In-vehicle battery durability e-HDVs

Open Items

Elena Paffumi, Gian-Luca Patrone
EVE IWG 73rd , web-meeting,
June 9th-10th , 2024

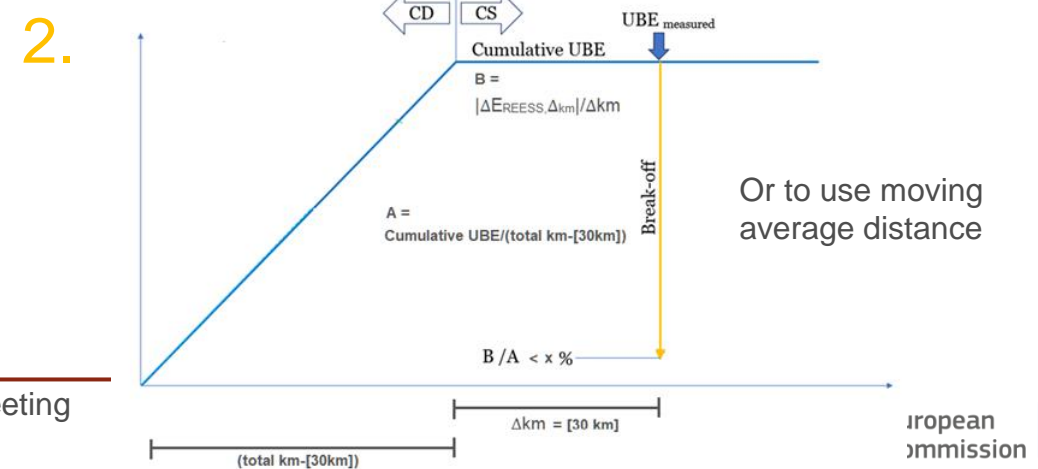
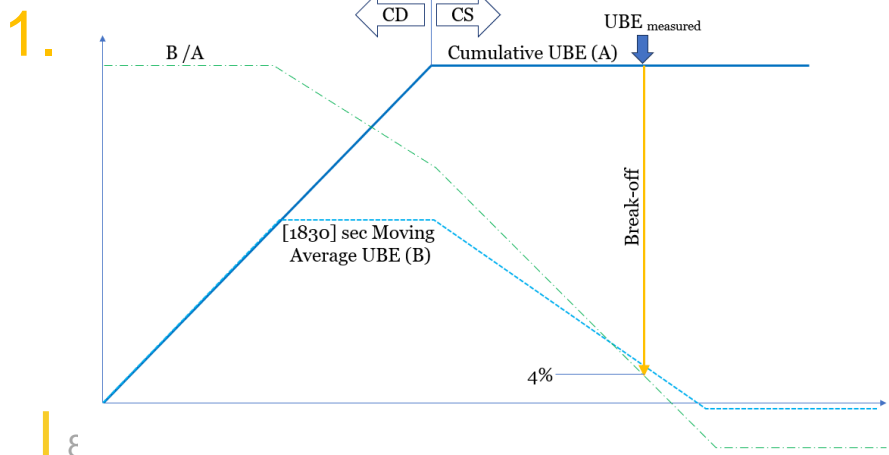
Japan: at least 1500sec ?
JE05 : 1830 sec
WLTP 4 : 1800 sec
WLTP 3 : 1477 sec

Japan: 4 per cent of cumulative UBE

30 km ?

2-3-5 per cent ?

1. [the $|\Delta E_{REESS,dt}|$ in the last xx dt of driving is equal to or less than xx per cent of the cumulative UBE. The manufacturer shall provide evidence to the responsible authority after the test that this requirement is fulfilled.]
2. [the $|\Delta E_{REESS,\Delta km}|/\Delta km$ in the last xx km of driving is equal to or less than xx per cent of the *cumulative UBE/(total distance travelled - Δkm)* (energy consumption before the last Δkm). The manufacturer shall provide evidence to the responsible authority after the test that this requirement is fulfilled.]

Method 1a Discharge by standard average speed on a test track

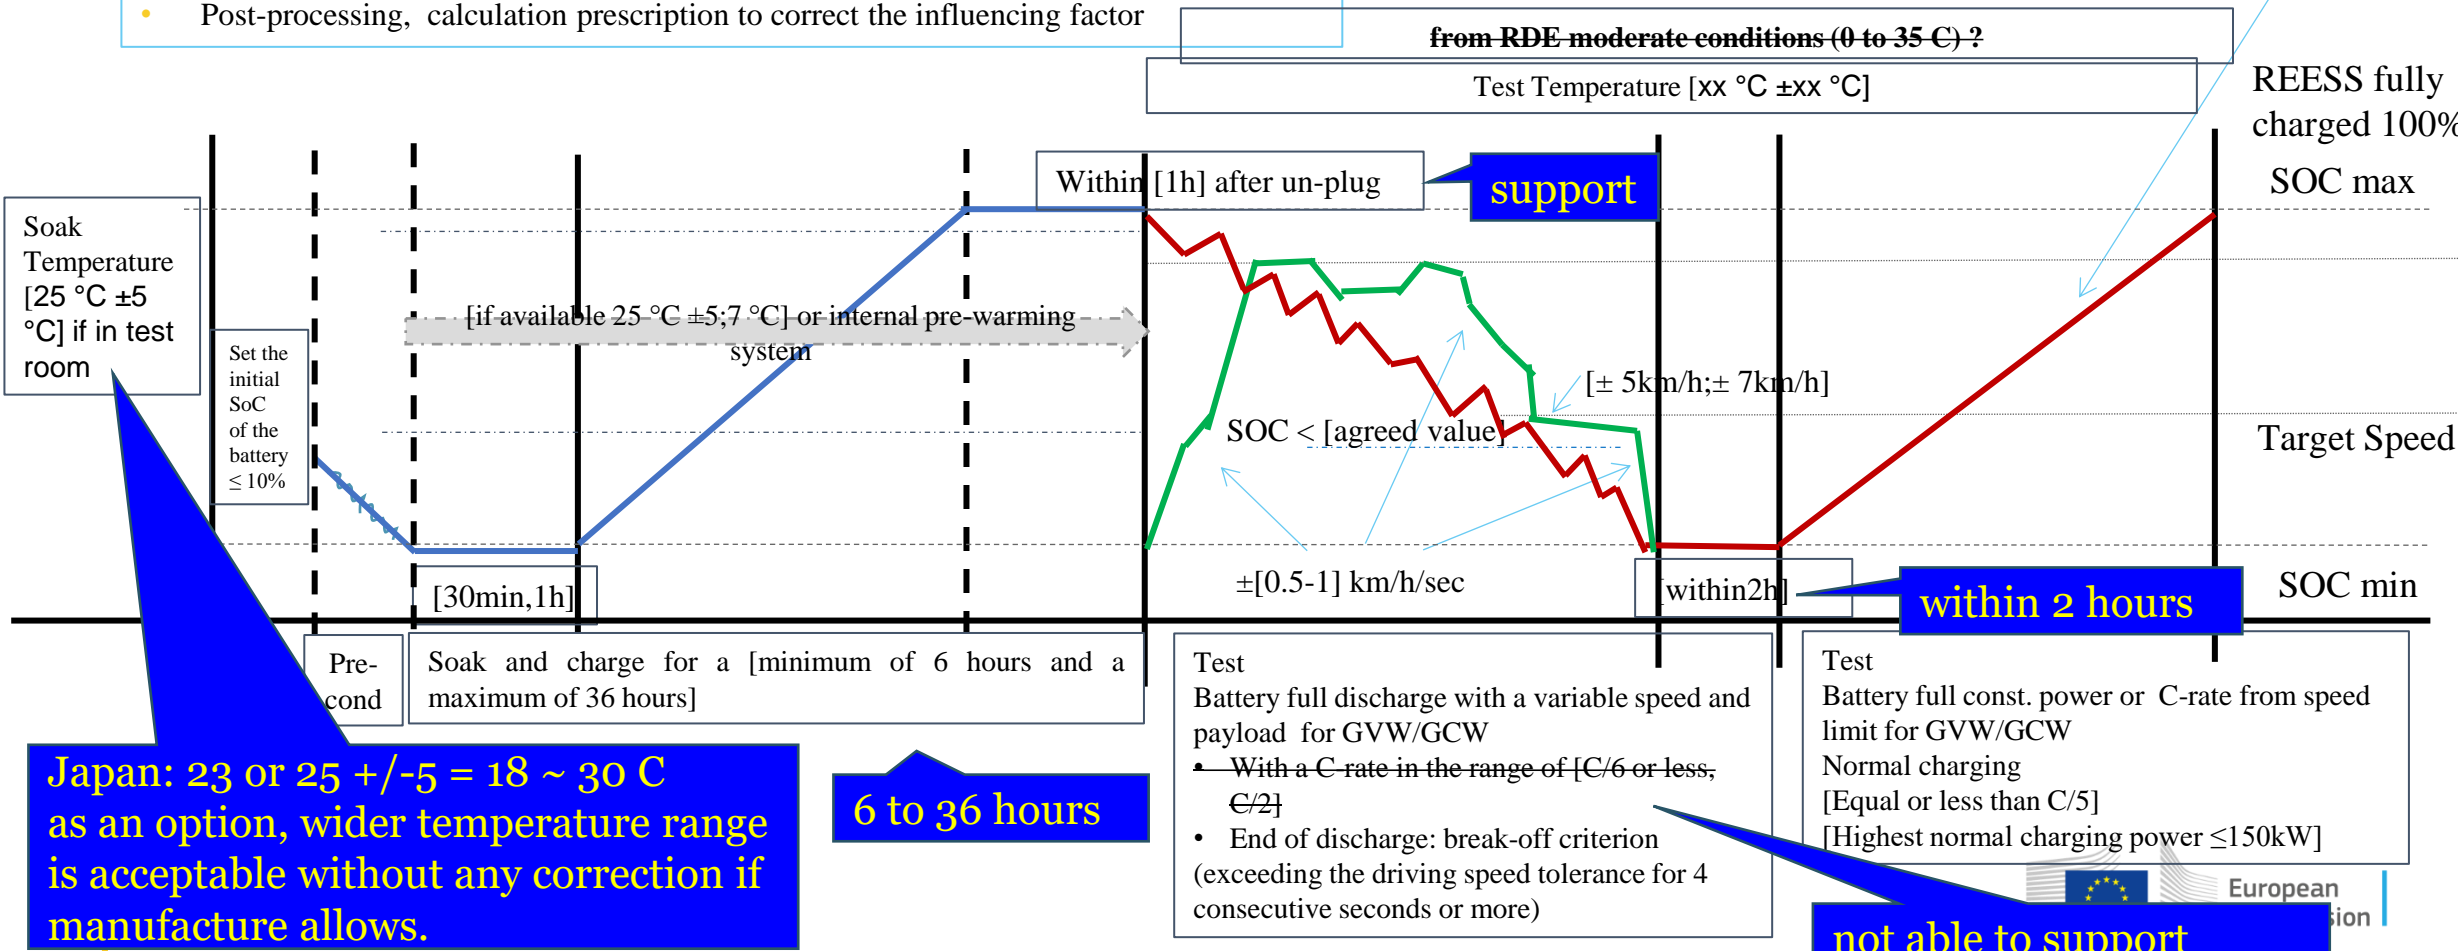
- Range of speed per category per region track
- To leave open the speed for the test and prescribe only the target speed in the last part of the test for which a speed tolerance will be applied
- The last part of the test starts when the SOC < [10%] (to be verified)
- Speed tolerance in last test segment [$\pm 5\text{km/h}; \pm 7\text{km/h}$]
- The acceleration/deceleration during vehicle speed change shall be smooth and accomplished within the range $\pm[0.5-1]$ km/h/sec
- End of discharge: break-off criterion
- Temperature provision due to cold temperature effect

from RDE moderate conditions (0 to 35 C)?

Japan: 23 or $25 \pm 5 = 18 \sim 30\text{ °C}$ as an option, wider temperature range is acceptable without any correction if manufacture allows.

not able to support

Method 2 bidirectional charging system available

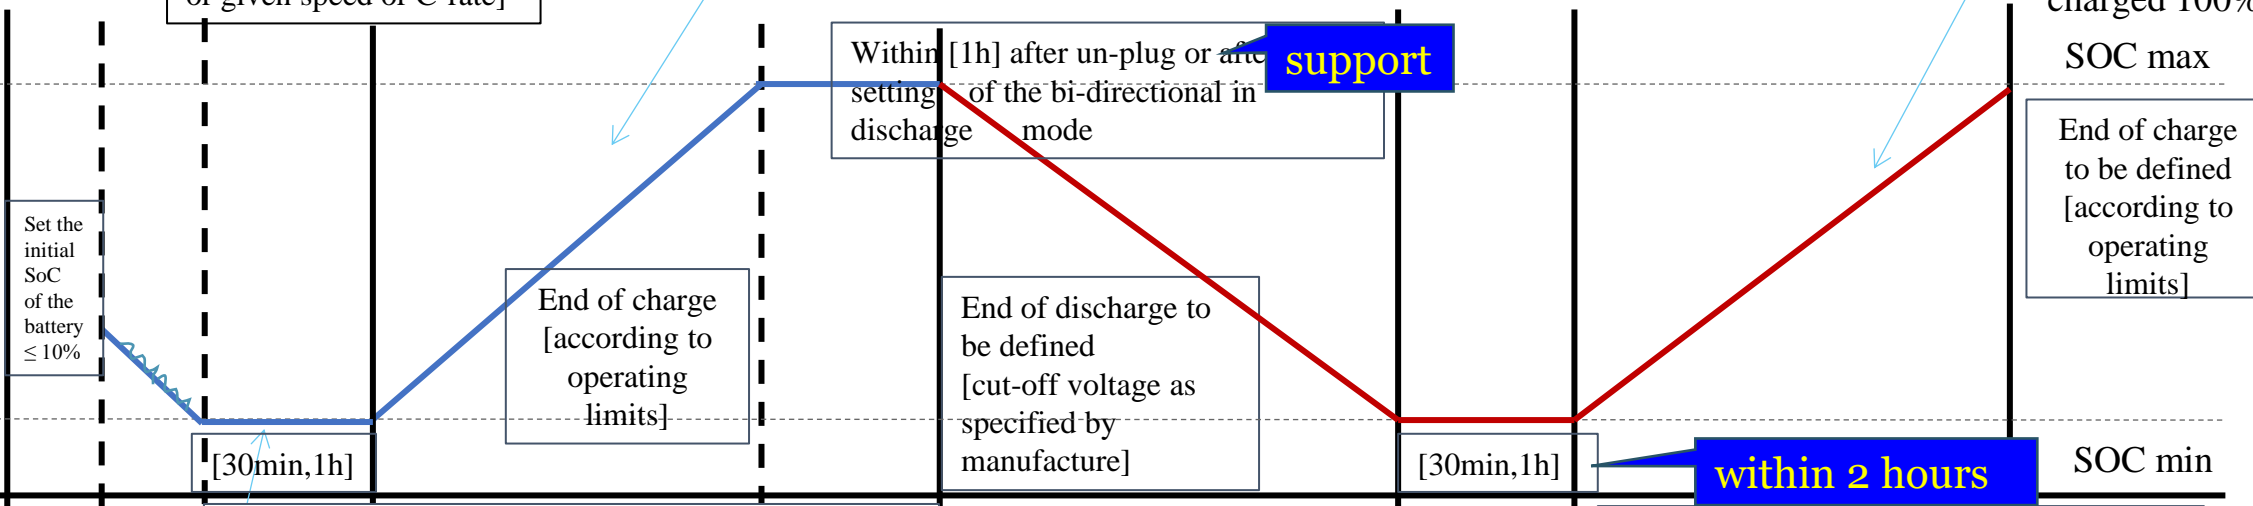
Japan: 23 or 25 +/- 5 = 18 ~ 30 C as an option, wider temperature range is acceptable without any correction if manufacture allows.

within 0 ~ 35 C

follow manufacture recommendation

not able to support

End of discharge to be defined for bi-directional charging test [Cut-off voltage]
